ERRATA for
FE Civil Practice Exam
ISBN: 978-1-932613-81-0
Copyright 2017
Errata posted 9/9/2019

Revisions are shown in red.

Solution 34, p. 84:

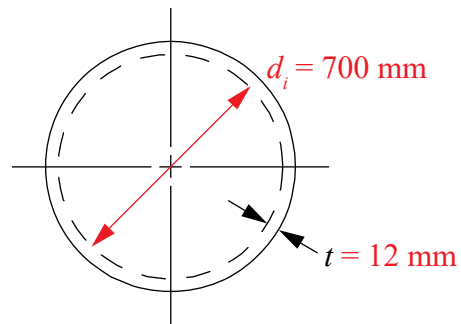
Refer to Cylindrical Pressure Vessel in the Mechanics of Materials section of the *FE Reference Handbook*.

The cylinder can be considered thin-walled if $\frac{t}{\frac{d_i}{2}} \leq 0.10$. In this case, $t = 12$ mm and $d_i = 700$ mm.

Since $\frac{t}{\frac{d_i}{2}} = \frac{12}{350} = 0.034$ which is ≤ 0.10 , the pipe is thin-walled.

$$\text{Thus } \sigma_t = \frac{P_i r}{t}$$

$$\text{where } r = \frac{r_i + r_o}{2} = \frac{350 + 362}{2} = 356 \text{ mm}$$

$$\sigma_t = \frac{(1.680 \text{ MPa})(356 \text{ mm})}{12 \text{ mm}} = 49.8 \text{ MPa}$$

THE CORRECT ANSWER IS: B

Question 67, p. 50:

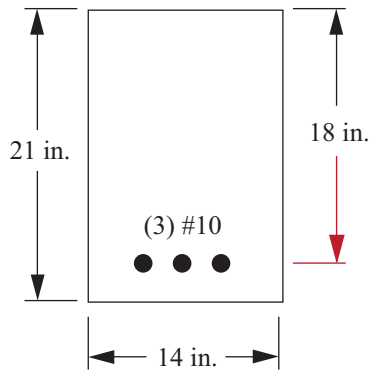
The figure should appear as follows:

$$f'_c = 4,000 \text{ psi}$$

$$f_y = 60 \text{ ksi}$$

Question 89, p. 62:

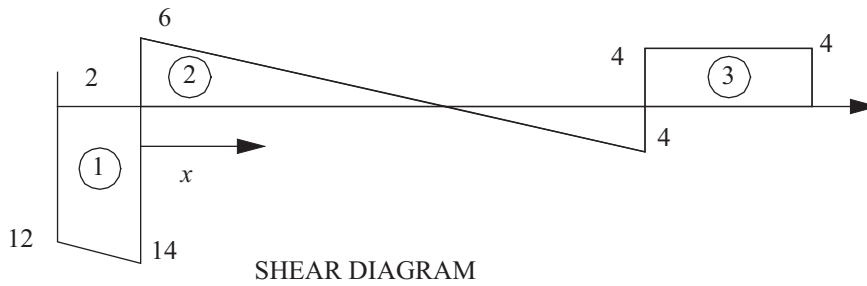
Question 89 has been replaced by the following:

Typically, groundwater is likely to contain high concentrations of:

- A. particles measured as turbidity
- B. microorganisms
- C. calcium hardness
- D. algae

THE CORRECT ANSWER IS: C

Solution 64, p. 96:

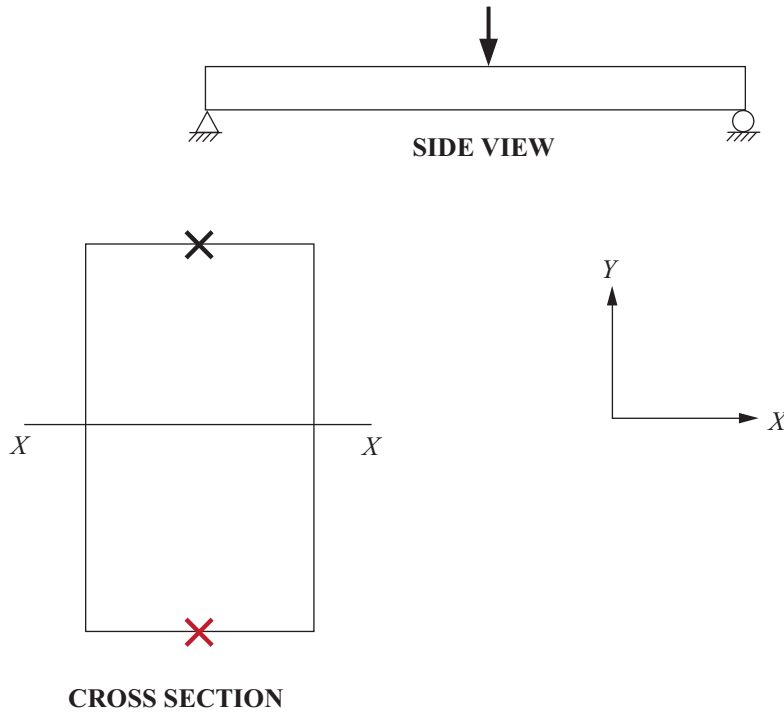
The figure should appear as follows:
